**ALERT SERVICE BULLETIN**

**NO.** 430-00-17

**SUBJECT:** HYDRAULIC ACTUATOR SUPPORT P/N 222-040-125-001, INSPECTION OF

**HELICOPTERS AFFECTED:** Model 430 helicopters serial number 49001 through 49064

**Hydraulic Actuator Support Assembly**  
**P/N 222-040-125-001**  
**Figure 1**

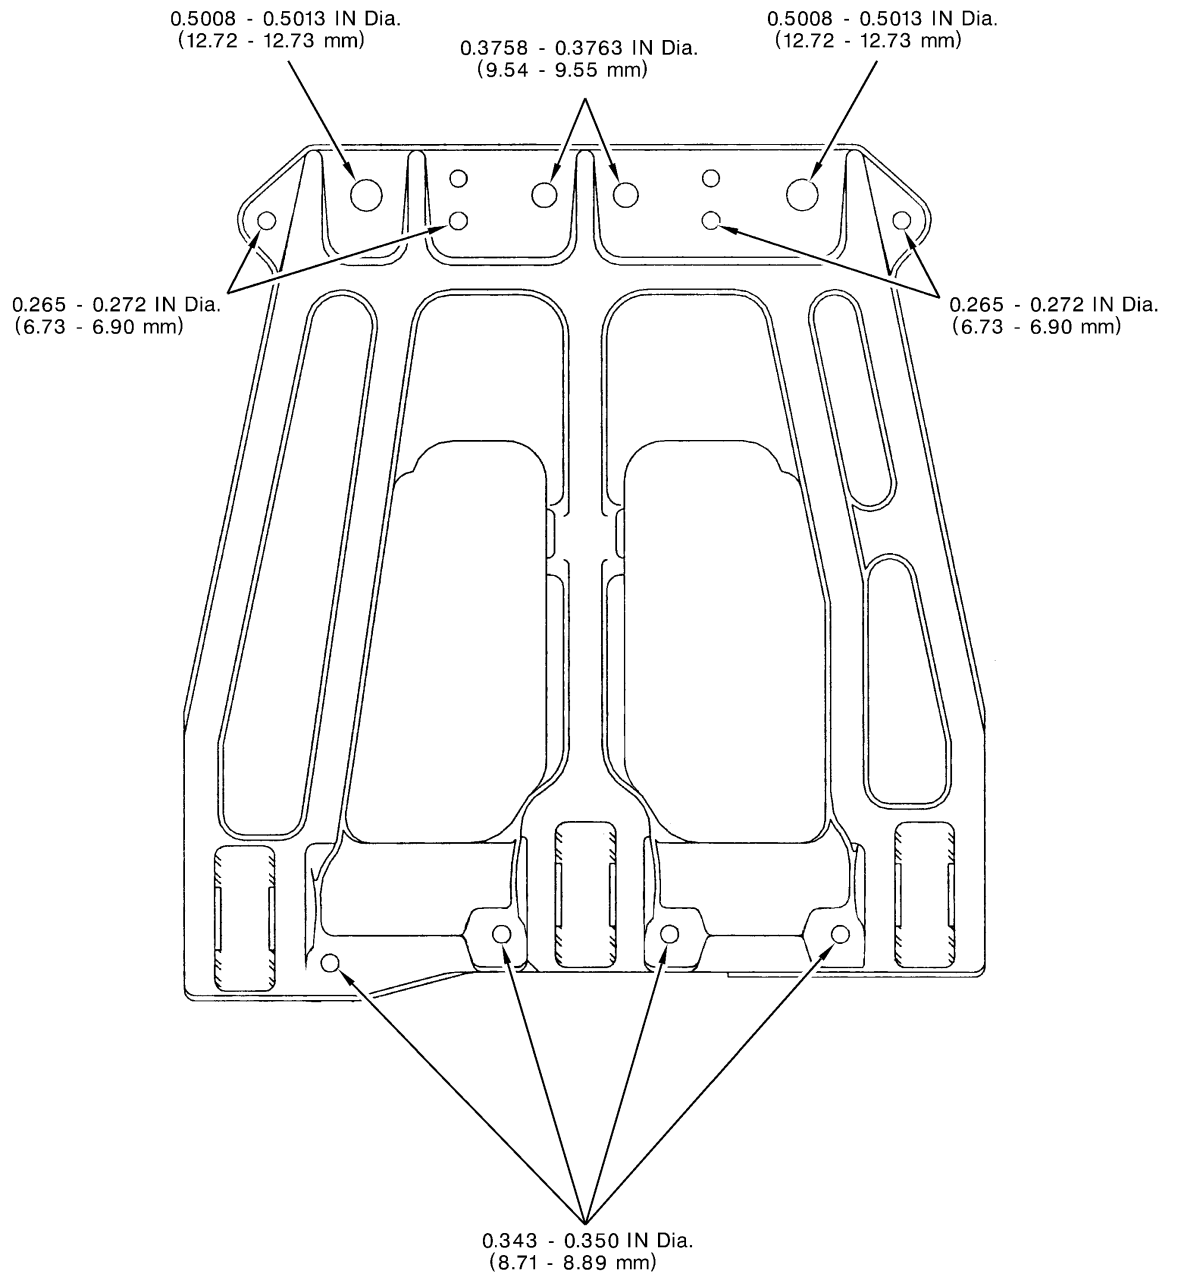
4. If two or more of the nuts within the upper row of the support attaching nuts move below 40 in.lb torque or two or more of the nuts within the lower row of the support attaching nuts move below 90 in.lb torque, remove the hydraulic actuators support from the transmission for further inspection and repair. Refer to BHT-430-MM-6, Chapter 63 and BHT-430-CR&O-2, Chapter 63 for removal instructions. Discard nuts and washers.
5. If required, inspect the support P/N 222-040-125-001 in accordance with instructions in BHT-430-CR&O-2, Chapter 63. The holes at the lower and upper end of the support were manufactured to the dimensions shown in Figure 1.

**Transmission Top Case Assembly**  
**P/N 430-040-061-101**  
**Figure 2**

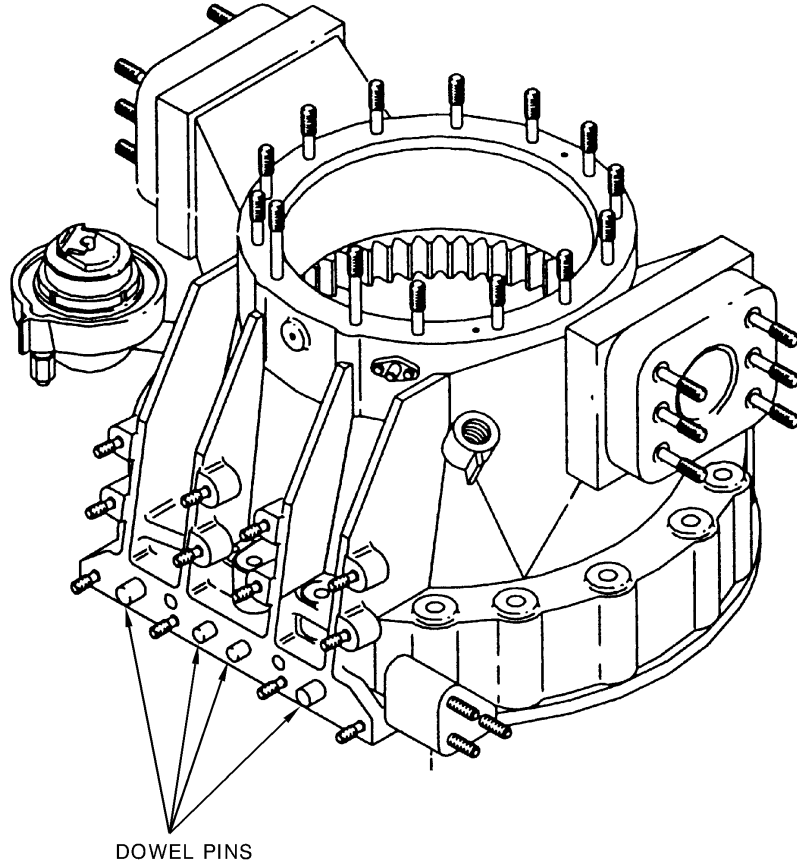
- c) Inspect the dowel pins in transmission case for damage, fretting, corrosion and looseness. The large outboard pins should measure 0.500 inch minimum and protrude 0.55 inch from the surface of the case. The small inboard pins should measure 0.375 inch minimum and protrude 0.45 inch from the surface of the case. Refer to Figure 2
